Project T10/1760-D

Revision 14
28 January 2008

Information technology - Serial Attached SCSI - 2 (SAS-2)

Summary of Comments on Serial Attached SCSI - 2 (SAS-2) Standard

Figure 16 — Port class diagram

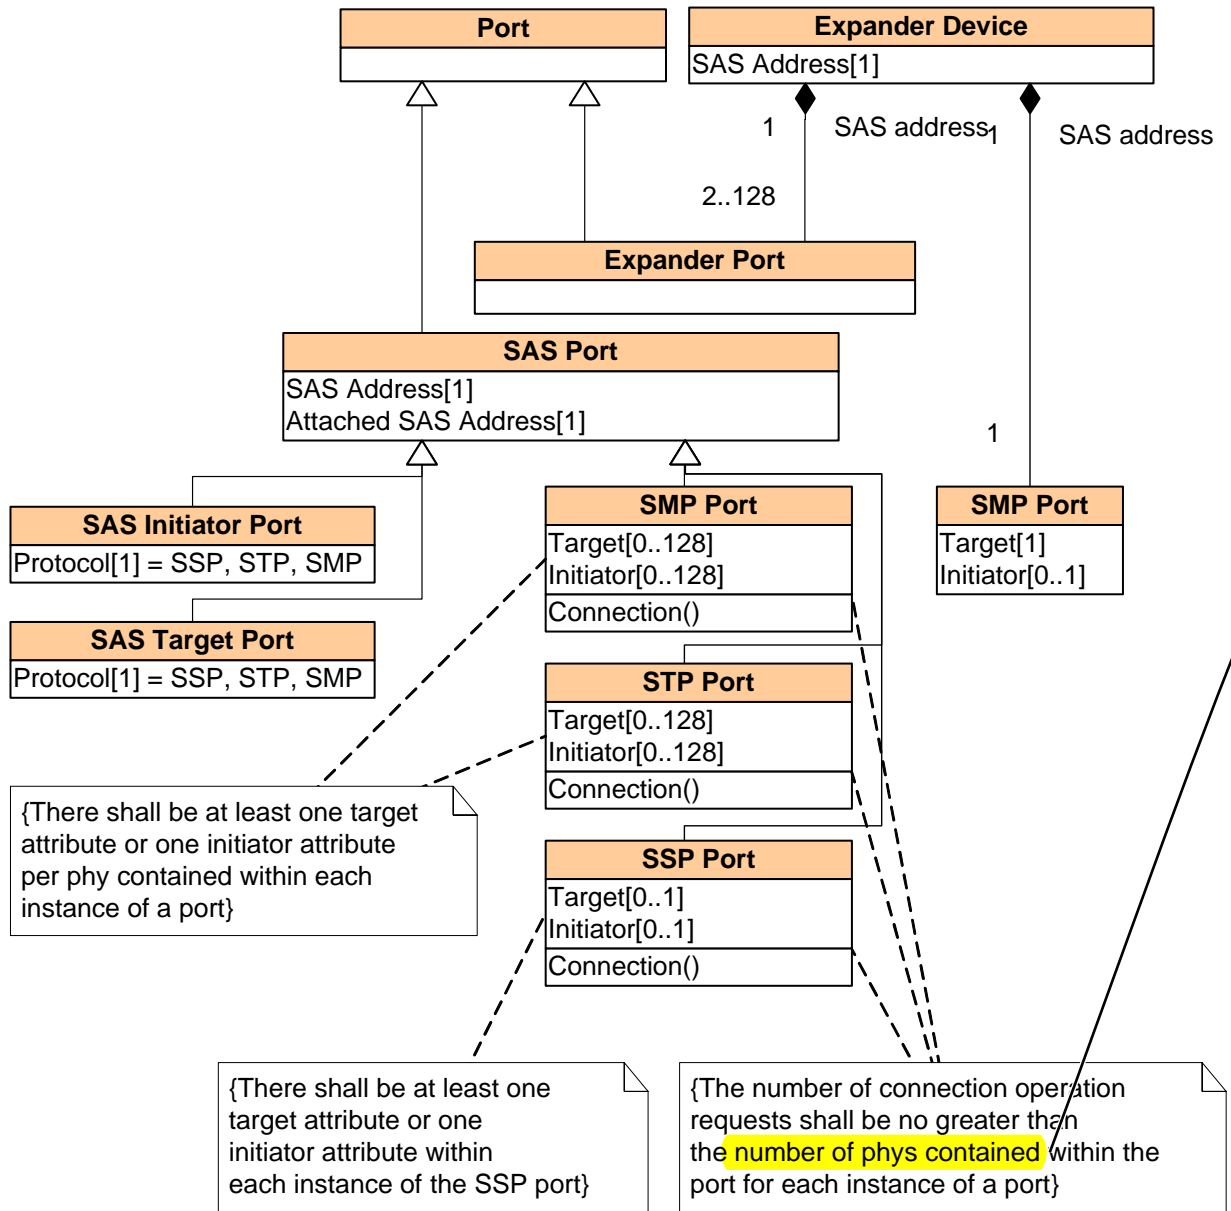
T Should be << detail is not shown. However, each port

Figure 28 — Multiple connections on wide ports

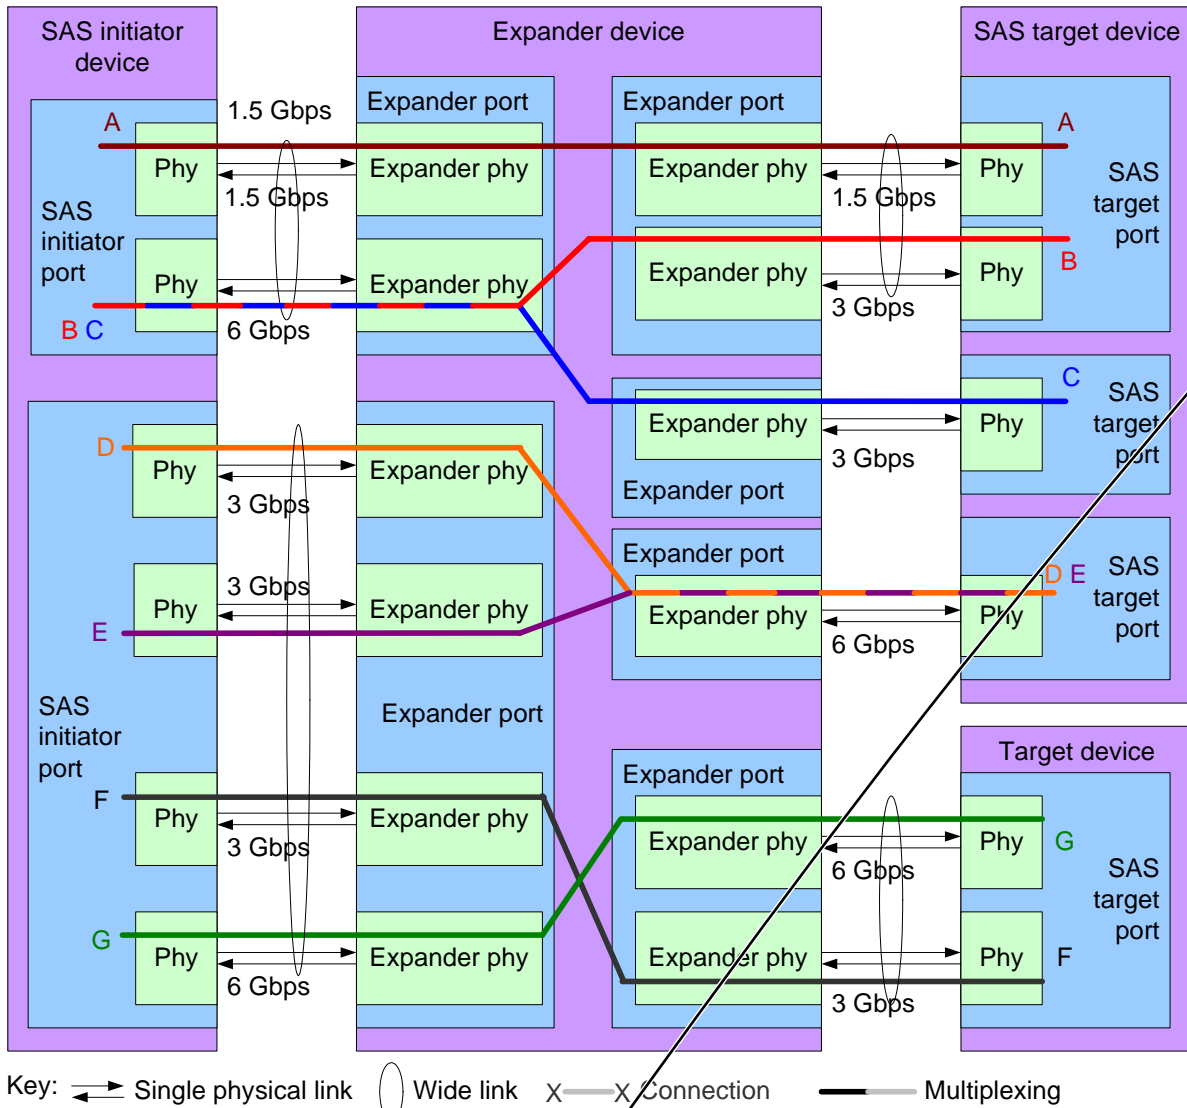
● Author: wdc-mevans
Subject: Highlight
Date: 3/28/2008 10:22:45 AM
T Additionally
s/b
In addition:

● Author: wdc-mevans
Subject: Highlight
Date: 3/28/2008 10:22:45 AM
T simultaneously
s/b
at the same time

Figure 155 — SP (phy layer) state machine - SAS speed negotiation states

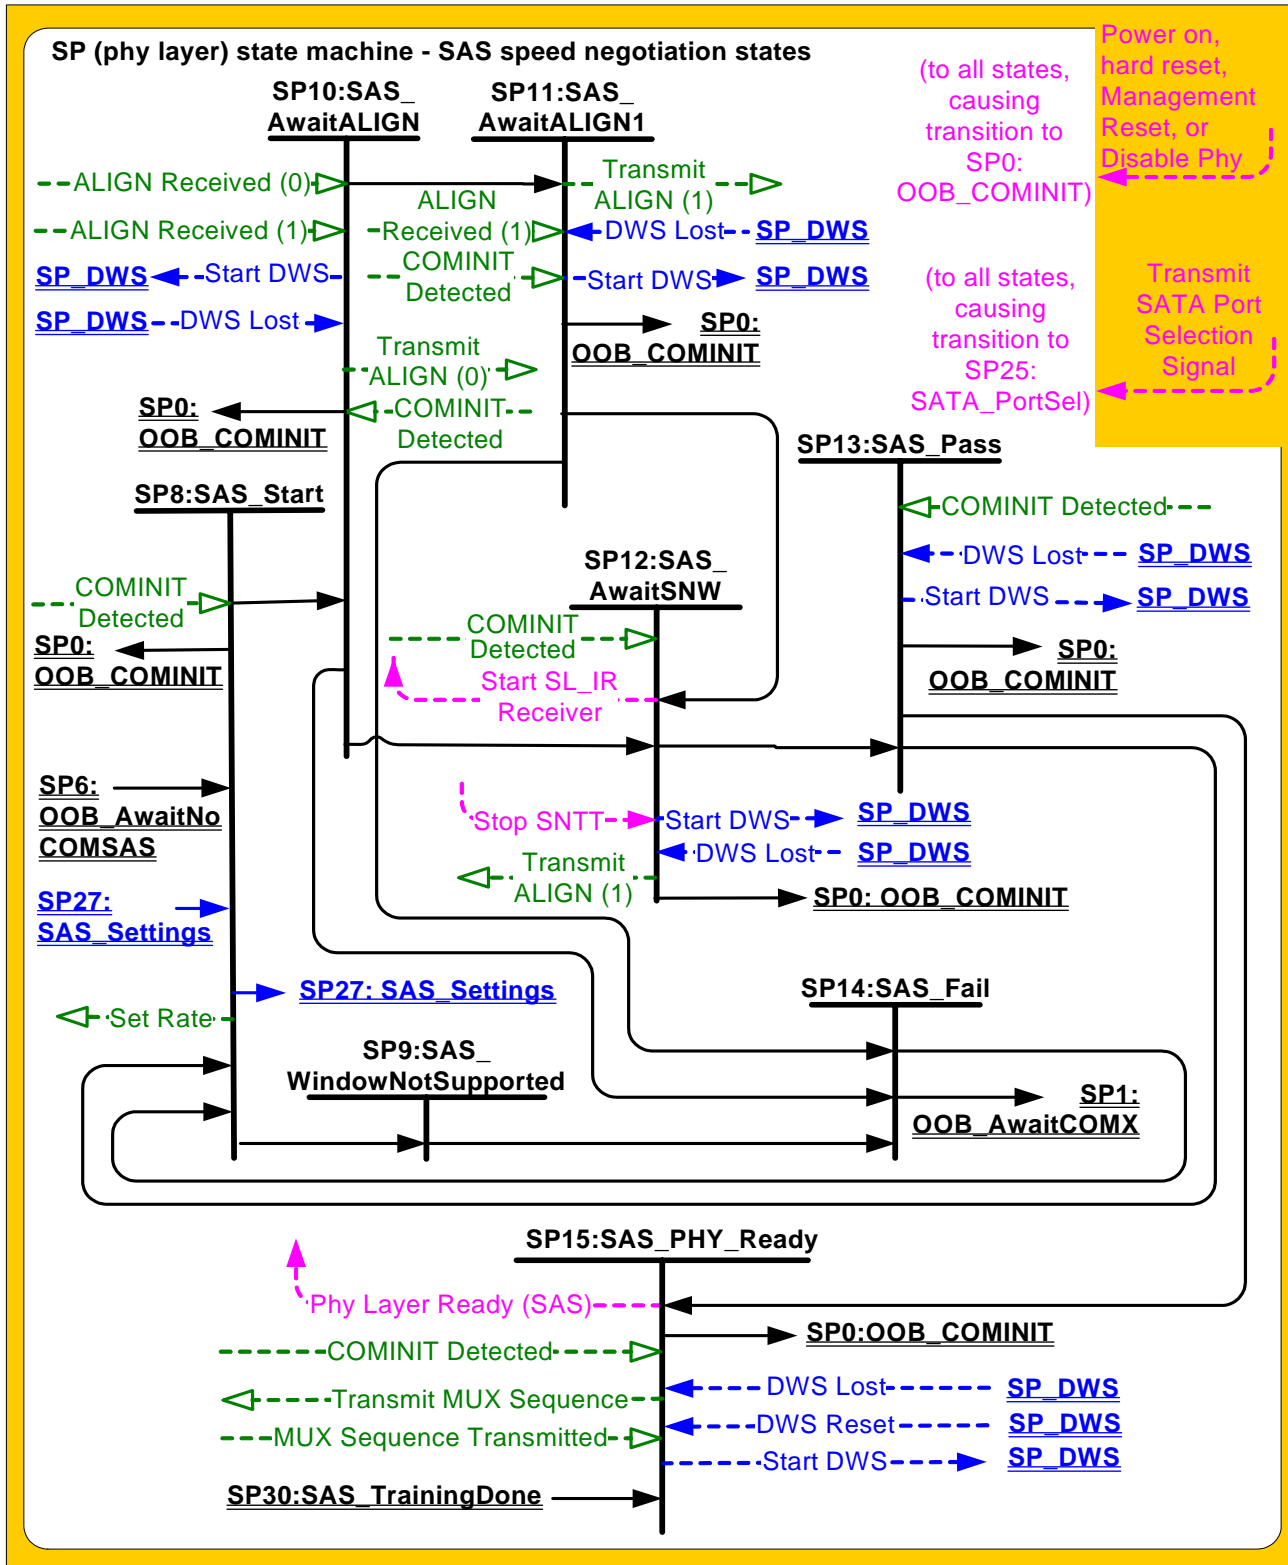
● Author: wdc-mevans
Subject: Highlight
Date: 3/28/2008 10:22:45 AM
T and performs
s/b
and the states in the state machine perform

Figure 157 — SP (phy layer) state machine - SATA host emulation states

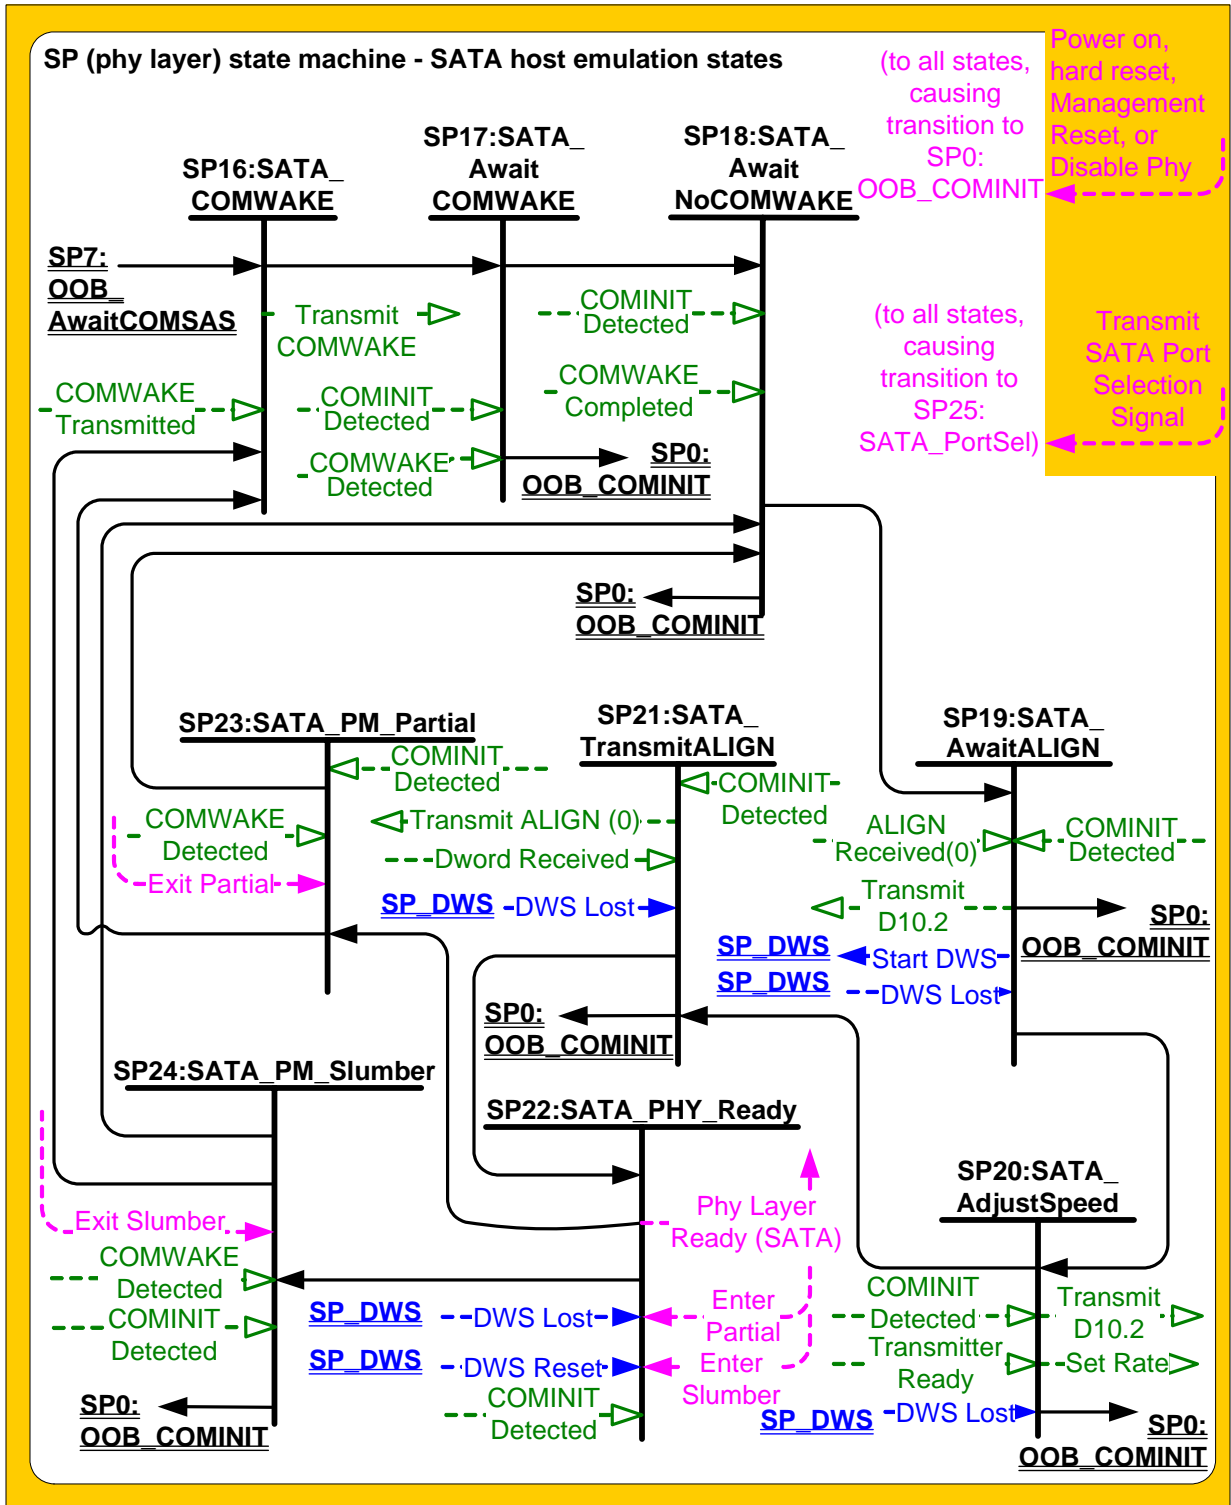
T SATA; expander
s/b
SATA. Expander
